Work Order ID 163000

DART AEROSPACE LTD		Work Order: 163000
Description: Bar		Part Number: D3196-1
Inspection Dwg: D3196	Rev: C	Page 1 of 1

DESIGN	DRAWN BY	DART AEROSPACE LTD	REV. C
00	JR	HAWKESBURY, ONTARIO, CANADA	
CHECKED	APPROVED	DRAWING NO.	SHEET 1 OF 3
PH	JR	D3196	
DATE	TITLE	SCALE	
06.10.31	BAR	1:4	
A	03.06.25	NEW ISSUE	
B	06.09.25	ADD D3196-5	
C	06.10.31	ADD SLOTS ON -1; REMOVED -5

DRAWING NO. D3196	TITLE BAR	REV. C	DART AEROSPACE LTD ENGINEERING ORDER	D.E.O. NO. D3196-C-1	SHEET NO. SHEET 1 OF 2	SCALE NTS
DRAWN <i>ASS</i>	CHECKED <i>[Signature]</i>	MFG. APPR. <i>[Signature]</i>	APPROVED <i>[Signature]</i>	DE APPR. <i>[Signature]</i>		
DATE 08.08.27	DATE 08.08.28	DATE 08.08.29	DATE 08.08.29	DATE 08.08.29	DATE 08.09.04

D3196-1 BAR

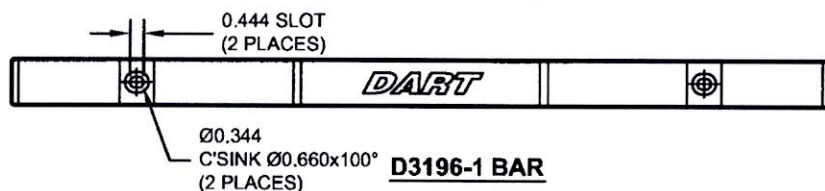
SHEET 1 MODIFY SLOT DIMENSIONING ON D3196-1 AS SHOWN:

D3196-3 BAR

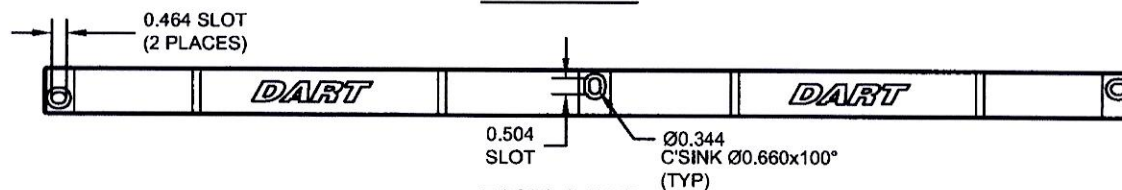
SHEET 2 MODIFY SLOT DIMENSIONING ON D3196-3 AS SHOWN:

D3196-4 BAR

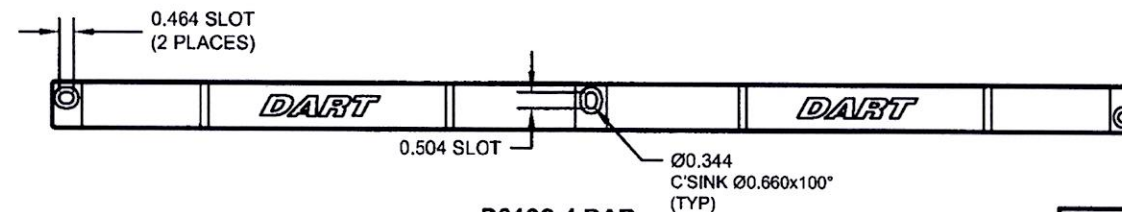
SHEET 3 MODIFY SLOT DIMENSIONING ON D3196-4 AS SHOWN:

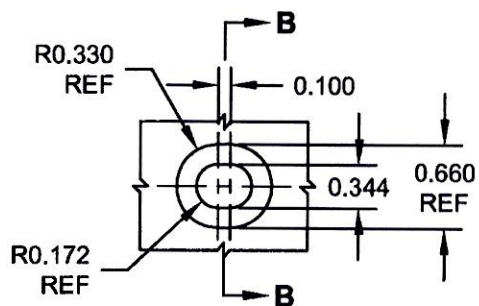
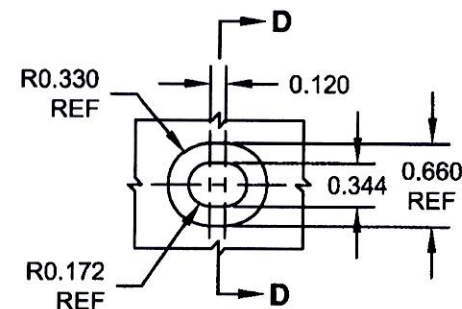
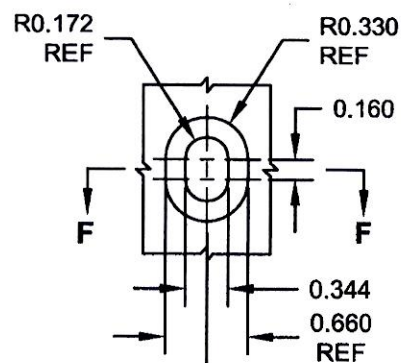
NOTE: THIS CHANGE HAS BEEN DONE TO CLARIFY SLOT DIMENSIONS ONLY. NO CHANGES HAVE BEEN MADE TO THE PARTS
SEE NCR 08-051 FOR FURTHER INFORMATION
ALL OTHER INFORMATION REMAINS UNCHANGED
